MISSISSIPPI POWER & LIGHT COMPANY

SUBJECT: Hydrogen Control Owners Group
(HCOG) Responses to NRC
Request for Additional
Information
File: 004,030
HGN-011

ATTACHMENT 1
RESPONSES TO REQUESTS FOR ADDITIONAL INFORMATION

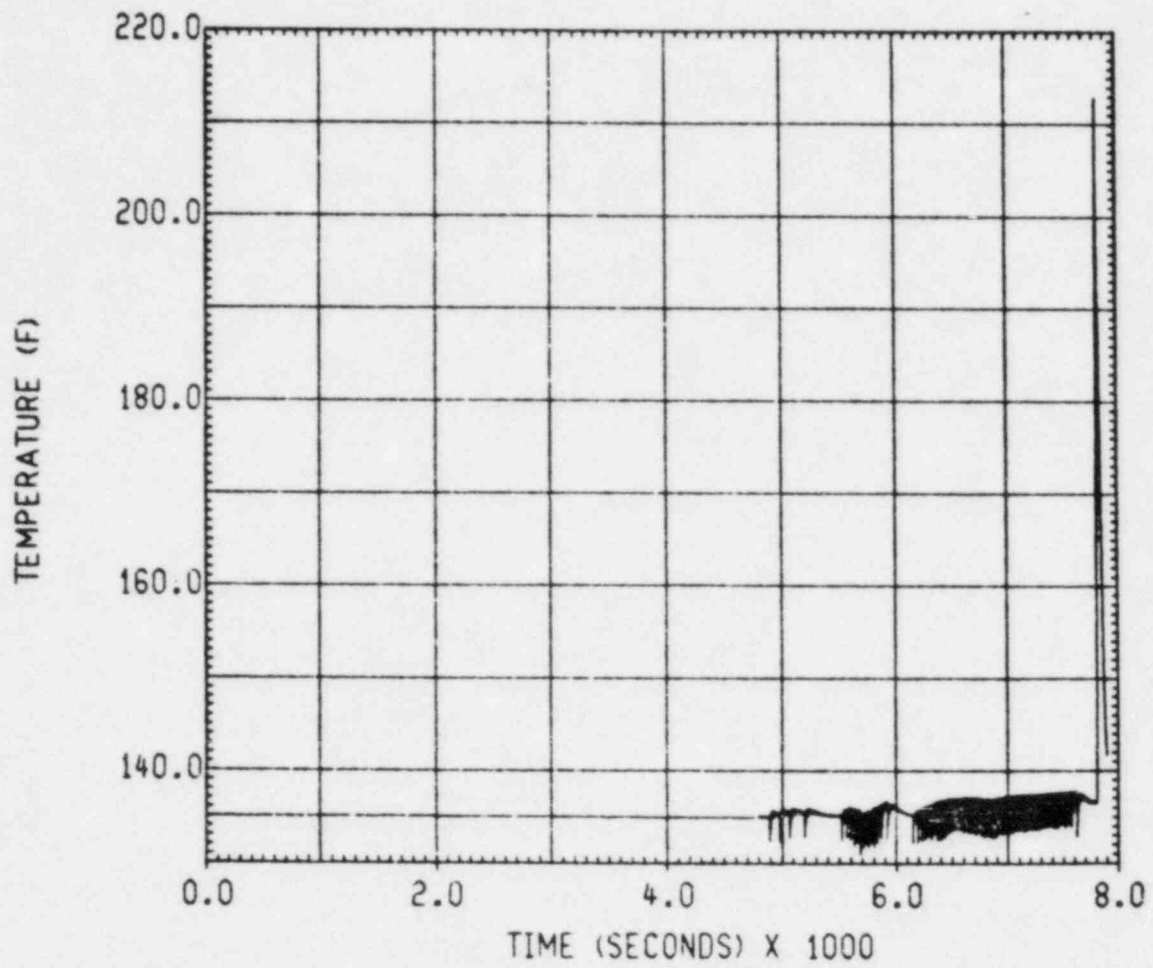
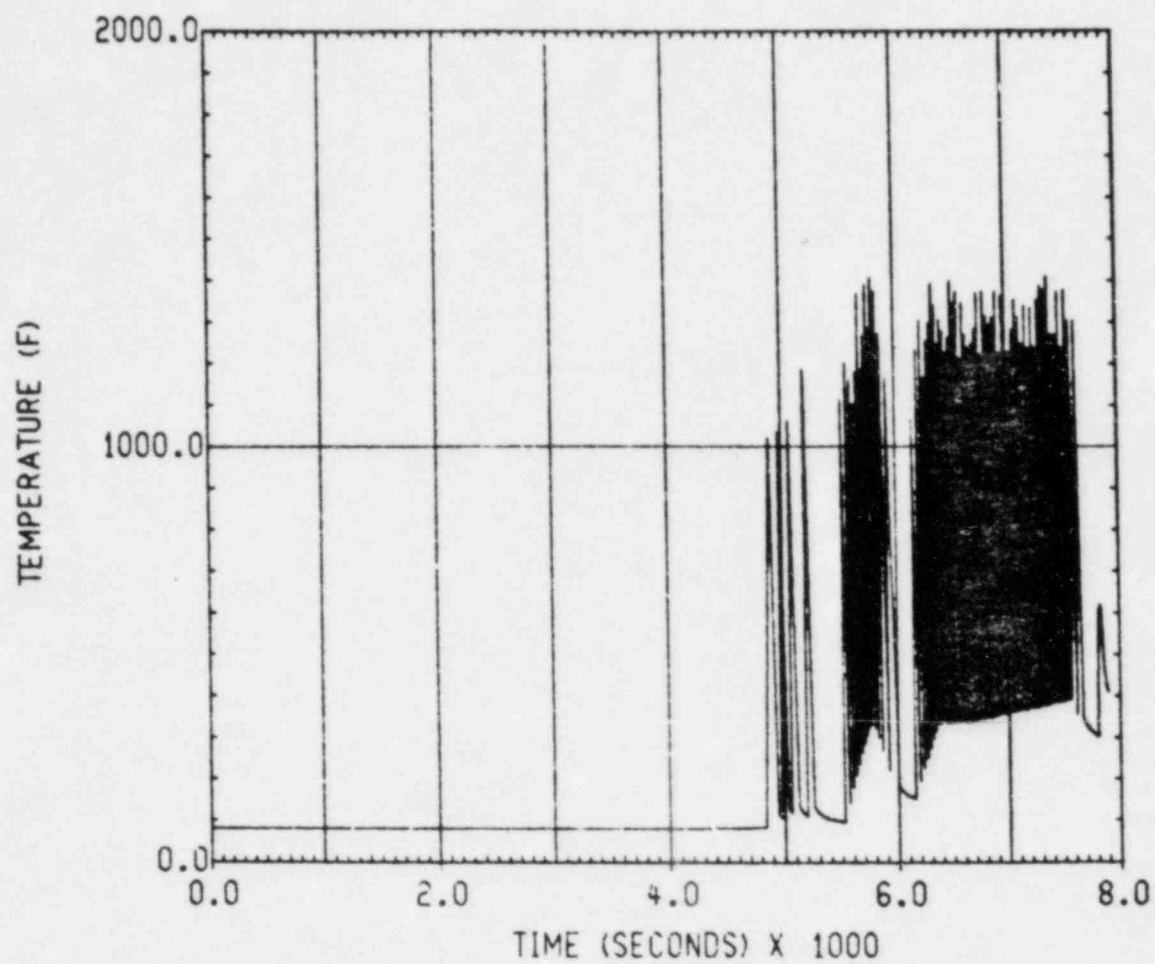
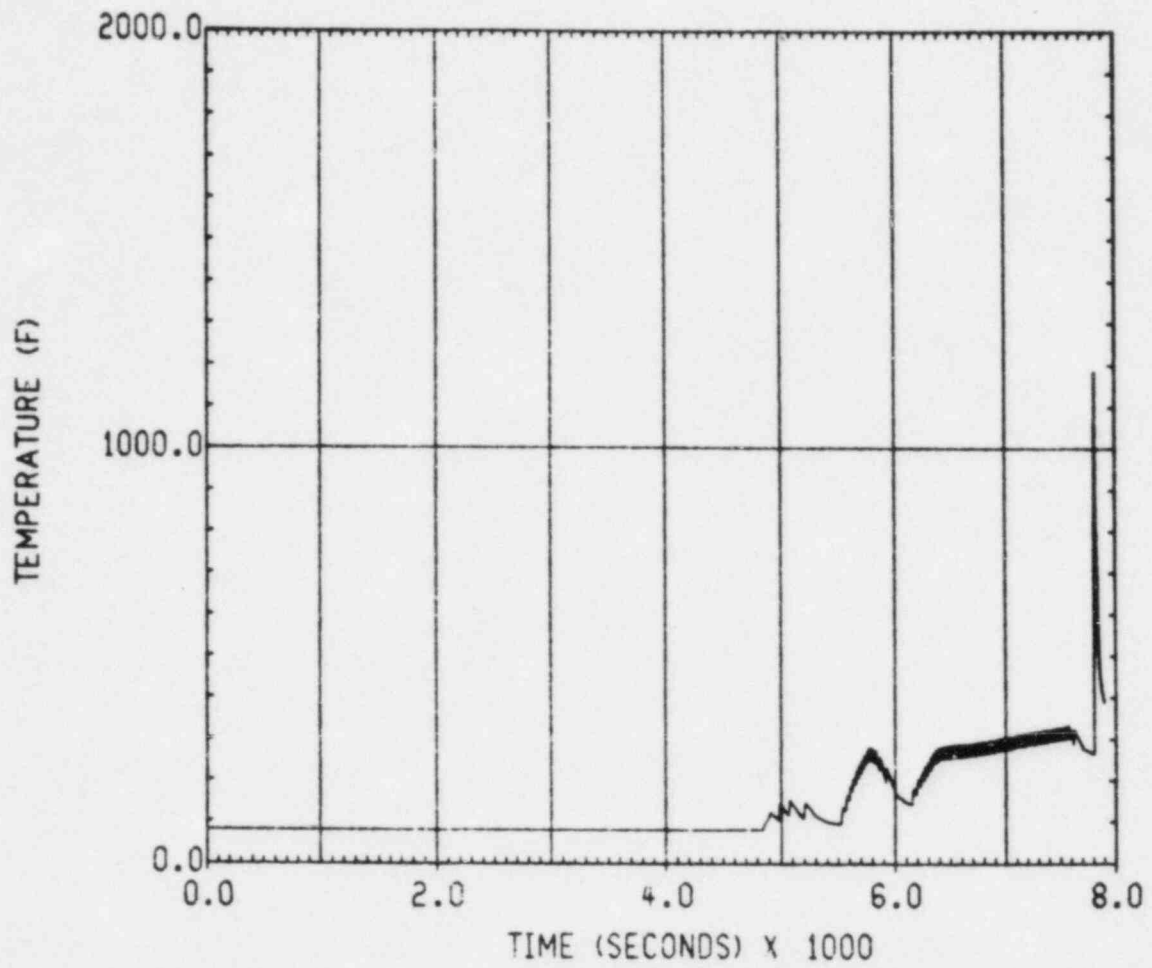
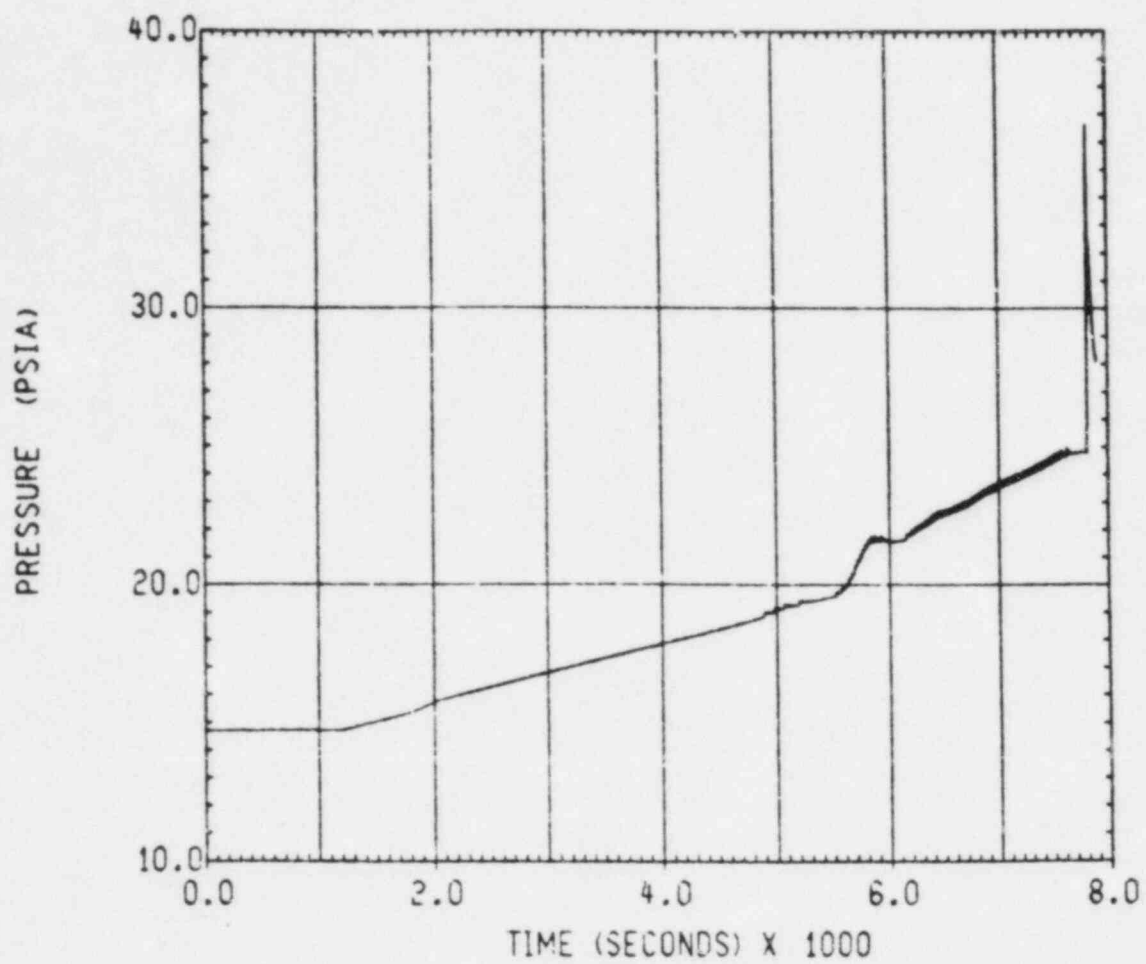
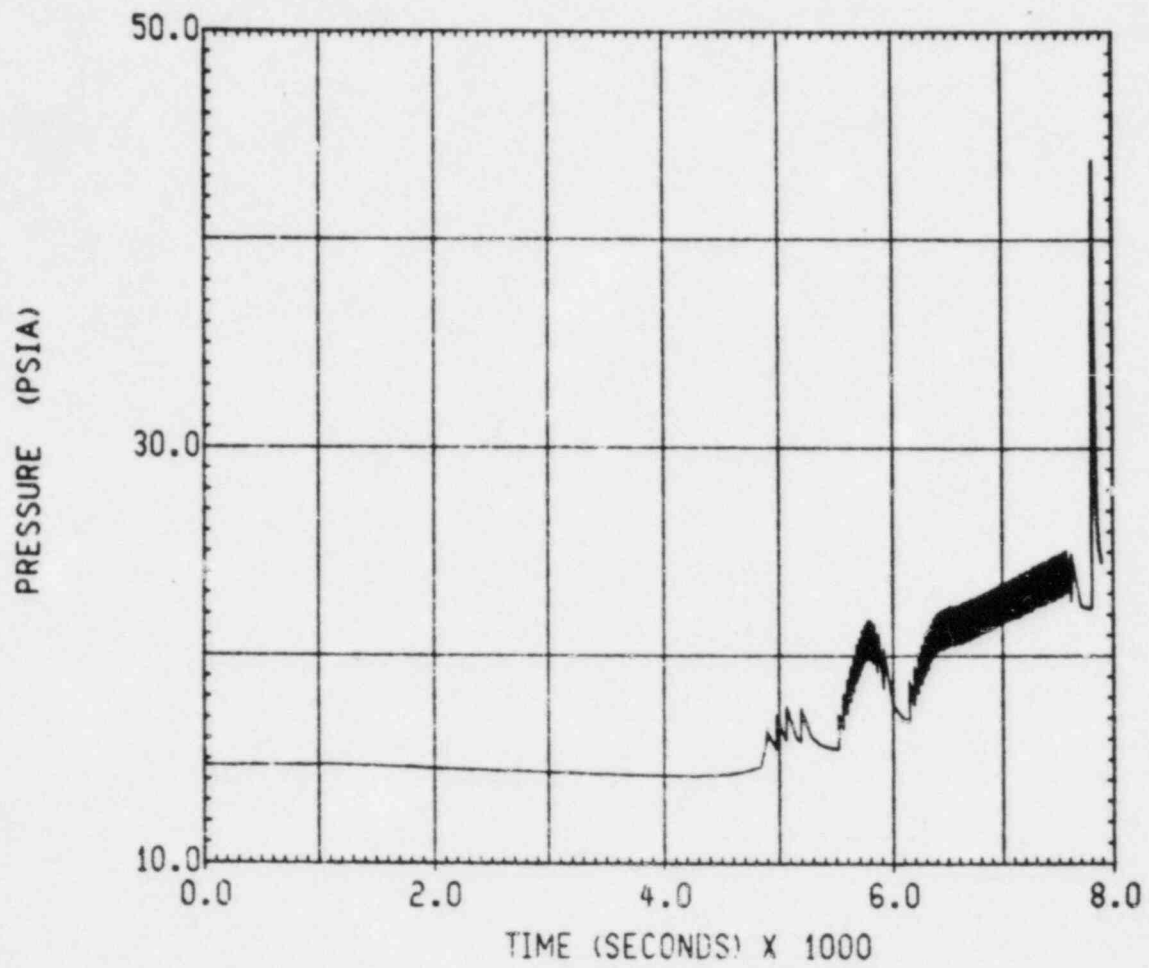
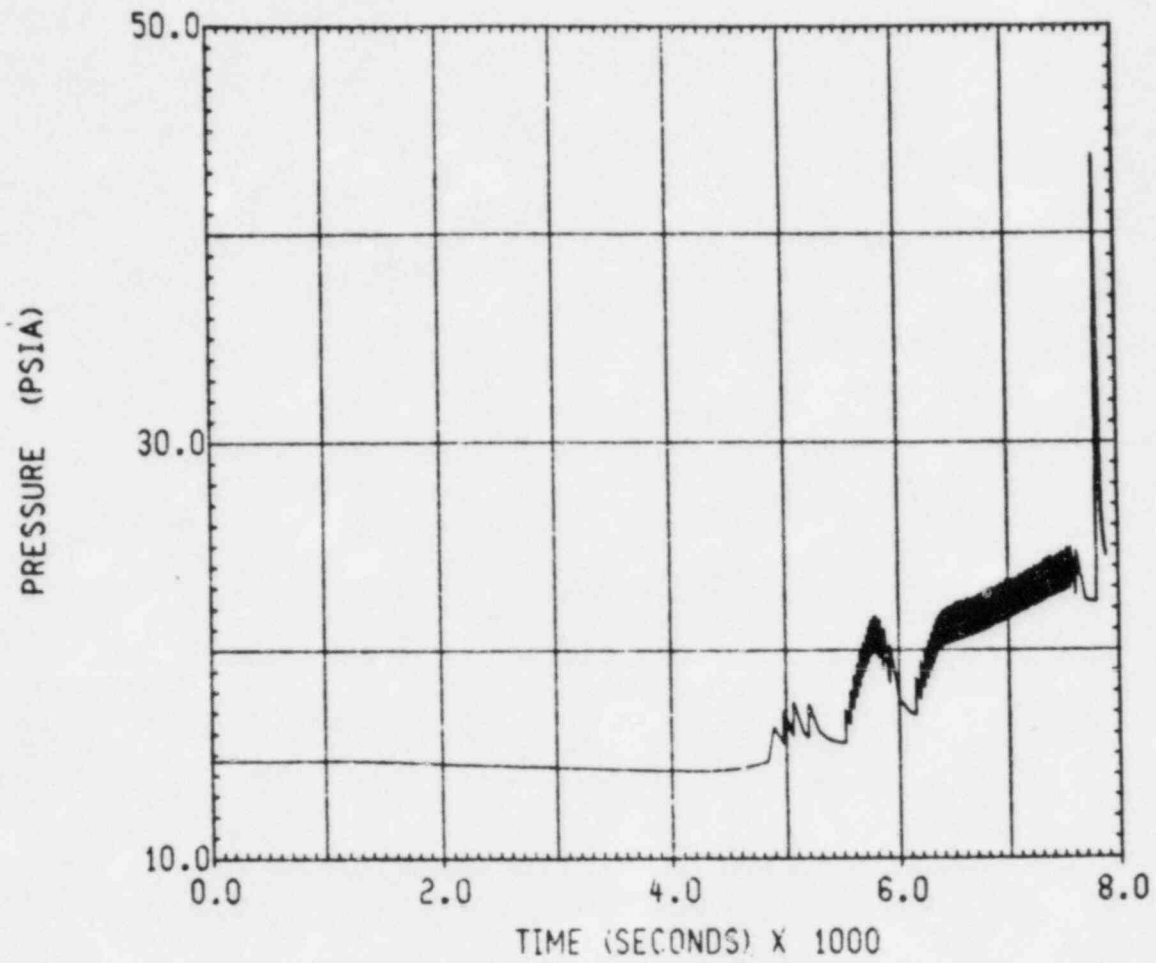
It appears that case SA-9 did not result in a containment burn due to the relatively high steam concentration suppressing the oxygen concentration to just barely below 5%. It is unreasonable to terminate the calculation if its extension would result in a containment burn due to gradual cooldown and steam condensation. Therefore when considering the above requests for additional analyses and when reevaluating case SA-9 do not terminate calculations when their continuation may result in significant hydrogen combustion. Furthermore the above arguments and the subject analysis (SA-9) performed to date was in reference to the postulated SORV accident. Provide similar analyses to that requested herein for the postulated small drywell break accident.

The Hydrogen Control Owners Group has extended the run for case SA-9 in order to resolve the stated concerns. The global burn in the upper containment was forced by arbitrarily reducing the oxygen concentration required to sustain combustion. The results from this are included in Figures 1 through 6.

It is important to note that the Hydrogen Control Owners Group has not terminated analyses when additional hydrogen combustion may occur. For example all drywell break cases were extended well

beyond the time at which hydrogen release was terminated which resulted in burns in the upper containment and in the drywell. In addition, the Hydrogen Control Owners Group forced a single global burn to occur in the stuck open relief valve (SORV) base case even though the code does not predict conditions capable of eliciting the global burn.
